Access Compliance Report

Public Rights-of-Way

(Curb Ramps)

Intersection ID: 4823	Main Street: BEN_CRAIG_DR	Cross Street: J_N_PEASE_PL	Location: SW
ADA ID: 4ABFB3003C58	Ramp Type: PerpDiag	Initial Pass/Fail: Fail	Overall Compliance: No
Severity Score: 25			
Codes/Mitigation Info/Possible Solution		Field Measurements/Component Compliance

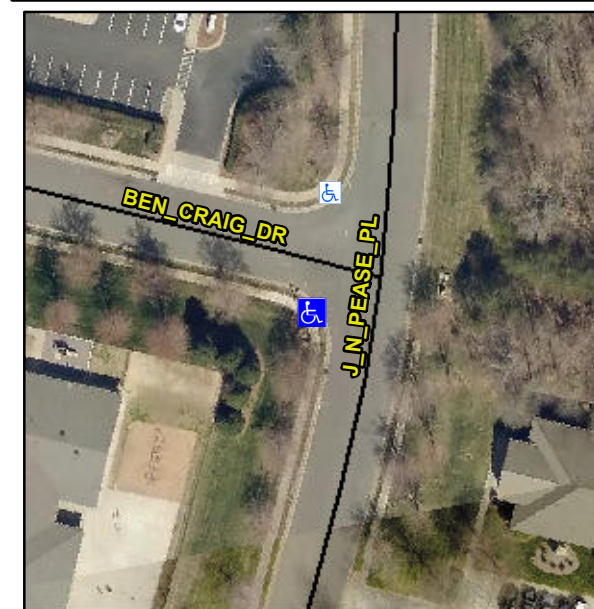
Not Found, R304.2.2, R304.5.3

Compliance	Description	Data	Compliance	Description	Data
N/A	Ramp Length (in)	36.0	No	Ramp Slope (%)	9.6
Yes	Ramp Width (in)	48.0	No	Ramp XSlope (%)	6.7
N/A	Flare Type LT	N/A	N/A	Flare Type RT	N/A
N/A	Flare Slope LT (%)	N/A	N/A	Flare Slope RT (%)	N/A
N/A	Flare Traversable LT?	N/A	N/A	Flare Traversable RT?	N/A
N/A	Landing Length (in)	N/A	N/A	DWS Provided?	N/A
N/A	Landing Width (in)	N/A	N/A	DWS Contrast?	N/A
N/A	Landing Slope (%)	N/A	N/A	DWS Length (in)	N/A
N/A	Landing X Slope (%)	N/A	N/A	DWS Full Width?	N/A
N/A	Landing Curb? (Y/N)	N/A	N/A	DWS Offset (in)	N/A
N/A	Shared Landing?	N/A			
N/A	Gutter Ponding?	N/A	N/A	Gutter Slope (%)	N/A
N/A	Gutter Lip Ht (in)	N/A	N/A	Gutter X Slope (%)	N/A
N/A	Painted X Walk1?	No	N/A	Painted X Walk2?	No
	X Walk 1 Direction	To E		X Walk 2 Direction	To N
N/A	X Walk 1 Width (in)	N/A	N/A	X Walk 2 Width (in)	N/A
	X Walk 1 Slope (%)	4.3		X Walk 2 Slope (%)	3.3
	X Walk 1 X Slope (%)	5.2		X Walk 2 X Slope (%)	3.0

Remove & Replace Curb Ramp With Two New Directional Ramps or Equivalent.
